State of Utah  
DEPARTMENT OF NATURAL RESOURCES  
DIVISION OF OIL, GAS AND MINING

Re: Response Adequacy from Cyprus Plateau Mining Corporation and Co-Op Mining Corporation  
Regarding the Birch Spring Monitoring Issues per: Tech Directive 005.

RE: Response Adequacy from Cyprus Plateau Mining Corporation and Co-Op Mining Corporation  
Regarding the Birch Spring Monitoring Issues per: Tech Directive 005.

Plate  
2-5  
1/12 KC

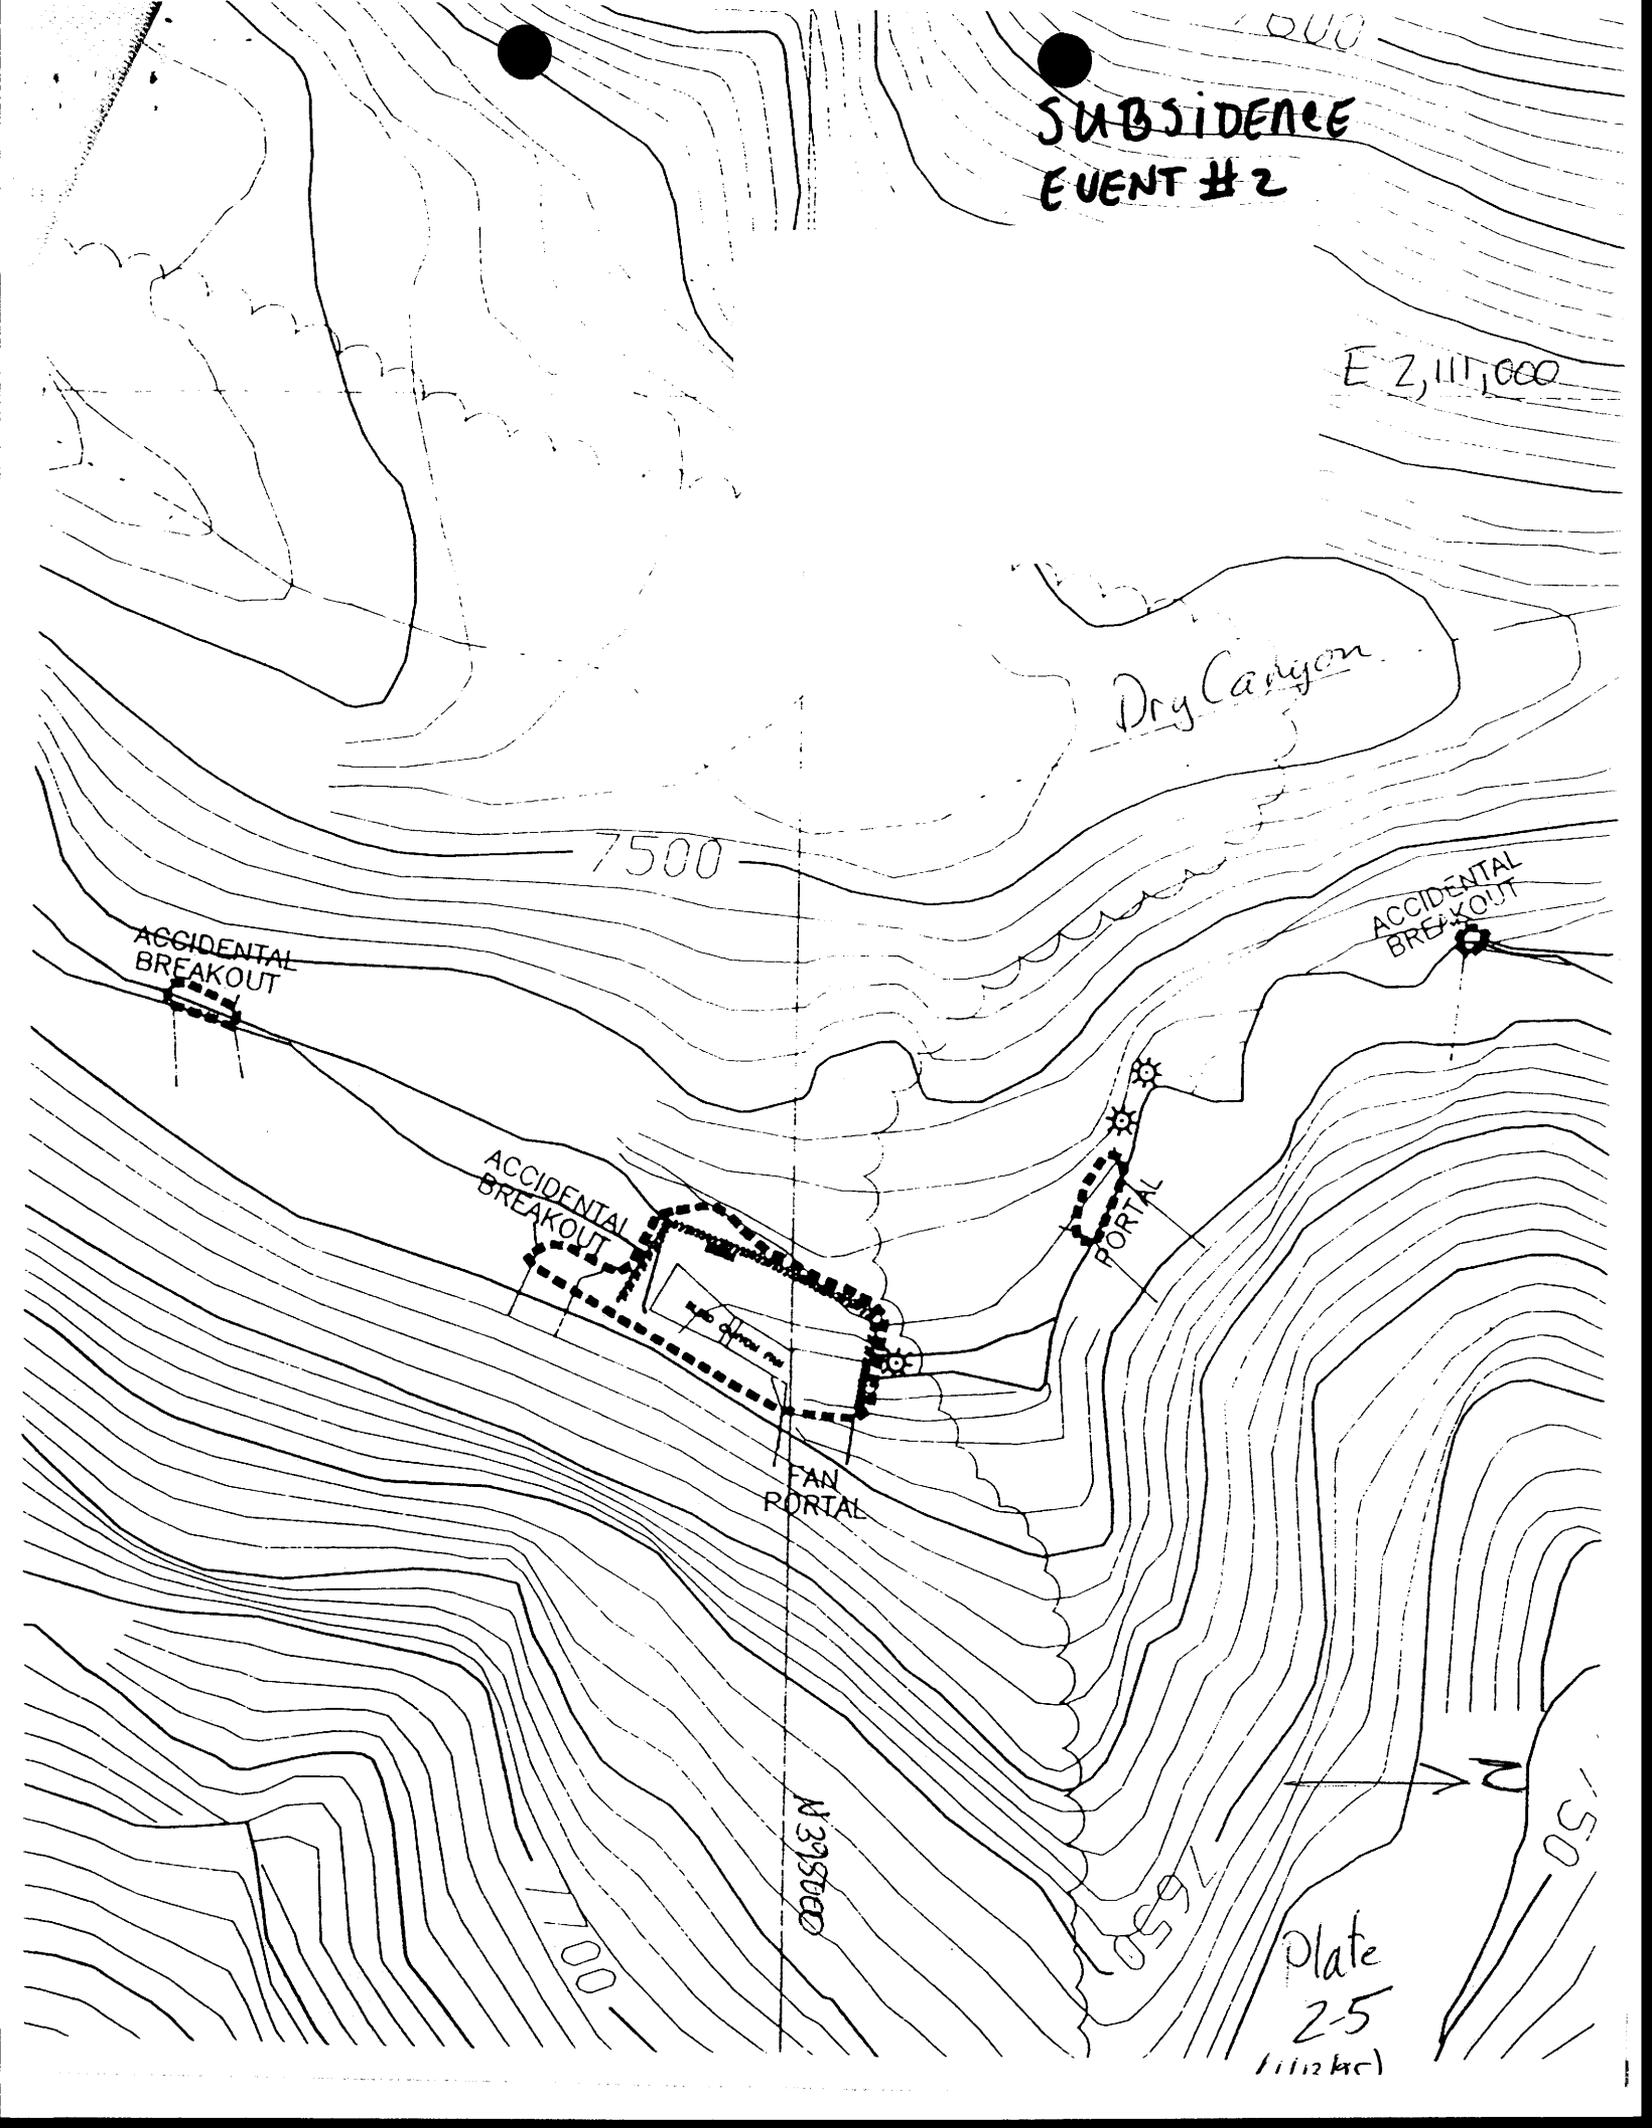
In response to Peter Hess's instructions, the permittee submitted this amendment for Division approval on January 19, 1995. The submittal consists of text and a map which have been revised to incorporate the 3 accidental breakouts in the approved plan.

In order to mitigate the damage caused by the breakouts, the permittee has included the 3 areas in the disturbed area and has committed to reclaim them by sealing them with a block wall and backfilling them, just like any portal opening. Plate 2-5, which shows the Blind Canyon fan portal, has been modified to show the locations of the breakouts. Since the addition to the approved disturbed area is so small, this action does not constitute a significant revision.

It is recommended 1) that this amendment be approved and included as part of the approved plan, and 2) that the bond be increased to at least \$502,120 to cover the additional reclamation costs associated with the breakouts.

Figure 1

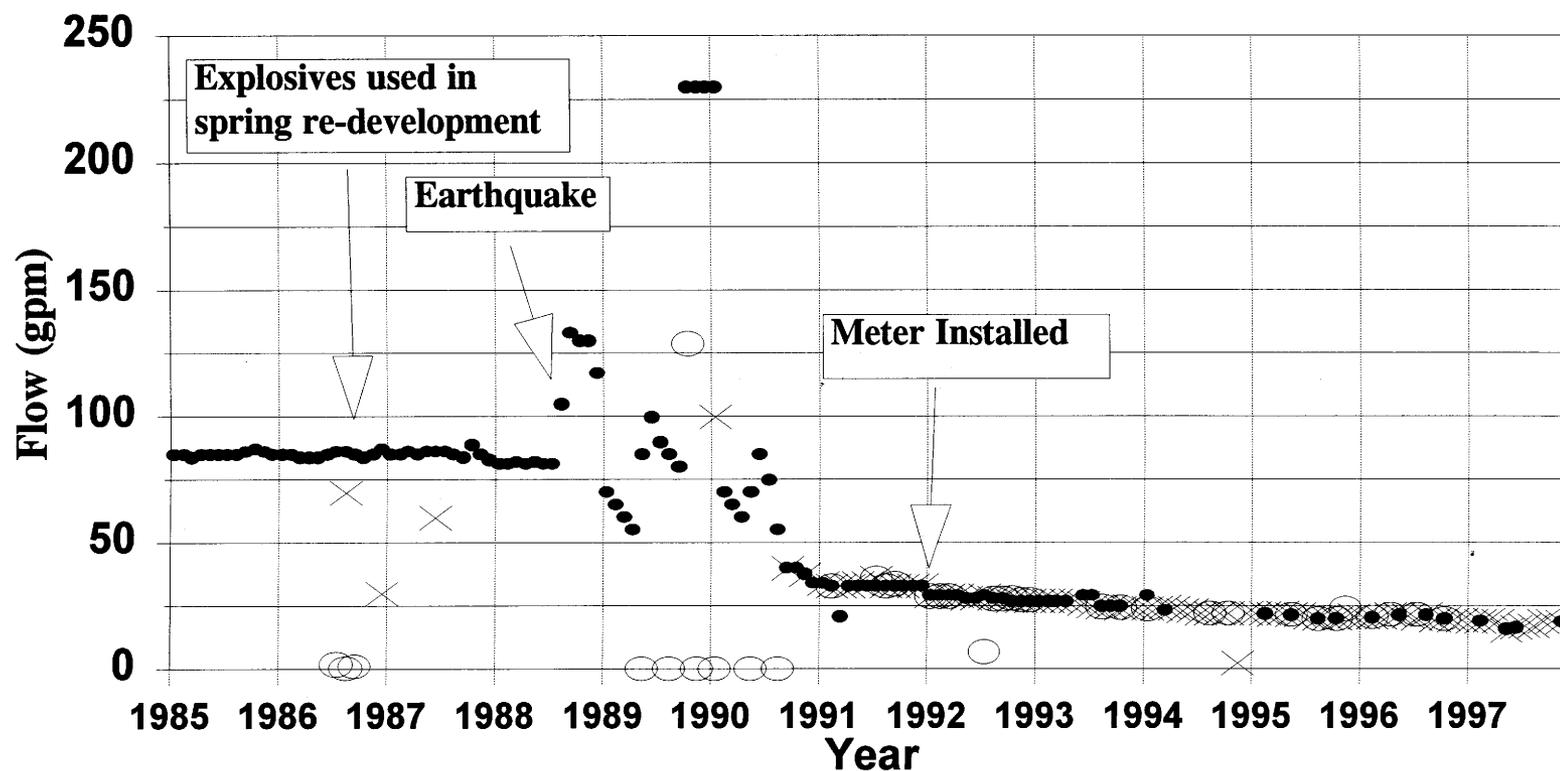
Recorded water flow data are summarized in Figure 1 in Appendix D. The data show two significant concerns. The first and main issue is the trend of decreasing flow since 1991, and perhaps earlier. Second is the increased flows or "peak flows" observed in August through December 1988, June 1989, and October 1989 through January 1990. The "peak flows" are discussed because of the possibility that they are related to the trend of reduced flow that followed them, although the cause or source for the "peak flows" appears to be separate from the normal flow from Birch Spring.

Based on the information provided by Cyprus in the Star Point Mine MRP, prior to the first "peak flow" the Birch Spring average discharge was 80 gpm. The recorded "peak flow" discharges reached 133, 100 and 230 gpm during August through December 1988; June 1989; and October 1989 through January 1990, respectively. Following the three periods of increased flows, the spring flow declined to 33 gpm in February 1990. Since that time the flow has diminished to about 19 gpm, with a low flow observed in May 1997 at around 16 gpm.

The reliability of flow measurement prior to 1990 is uncertain. Early data collected by Co-Op was obtained through measuring the flow from an overflow pipe and did not include flow traveling through the collection system. Early flow data presented by Cyprus was obtained by Ben Grimes, who is an employee of Cyprus Plateau Mining, through the North Emery Water Users Association (NEWUA) when Mr. Grimes was the NEWUA president. Mr. Grimes obtained these data from an older man who had measured the flows for NEWUA using unknown methods. This older man has since passed away and his records cannot be found. NEWUA has no record of the data that Cyprus attributes to NEWUA, and NEWUA data from this period do not agree with the Cyprus data.

FIGURE 2-2. Stiff Diagrams of Spring Water Analytical Results

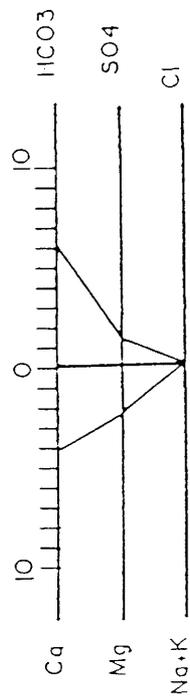
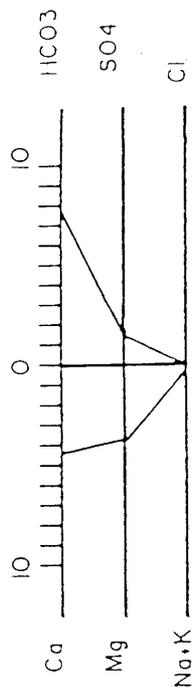
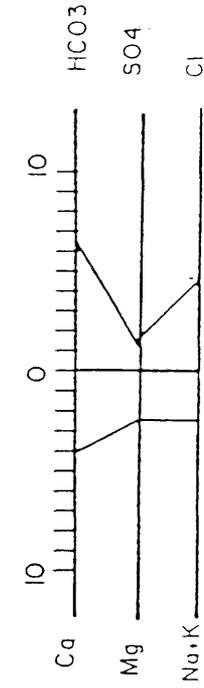
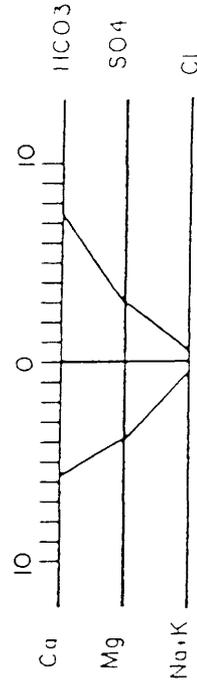
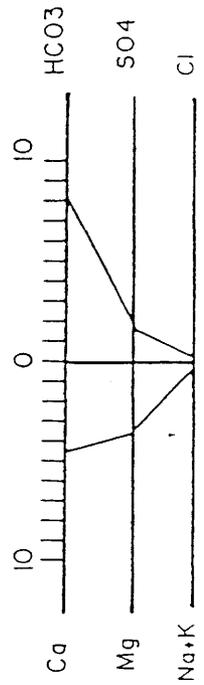
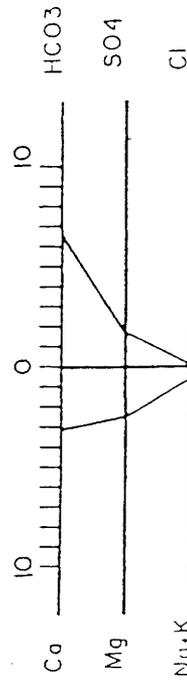
Data strongly indicating that Birch Spring water and in-mine water from SBC-9 are not the same are presented in the August 12, 1992 PHC in the Bear Canyon Mine MRP. This information shows SBC-9 has a greater concentration of sodium and chloride in comparison to Birch Spring. Bear and Trail Canyon Springs have Stiff diagrams similar to that of Birch Spring (Appendix E, figure 2-2).

However, the water quality used to construct the Stiff diagrams is an average and is therefore assumed to include the "peak flows". Water quality during these flows may not be characteristic and could greatly affect the determination of "average" qualities. It is not clear if water sampled at SBC-9 has historically been sampled as it flows from the channel sandstone or if samples were collected from the nearby sump. Waters collected from the sump and those from the sandstone channel should be clearly identified and analyzed separately.
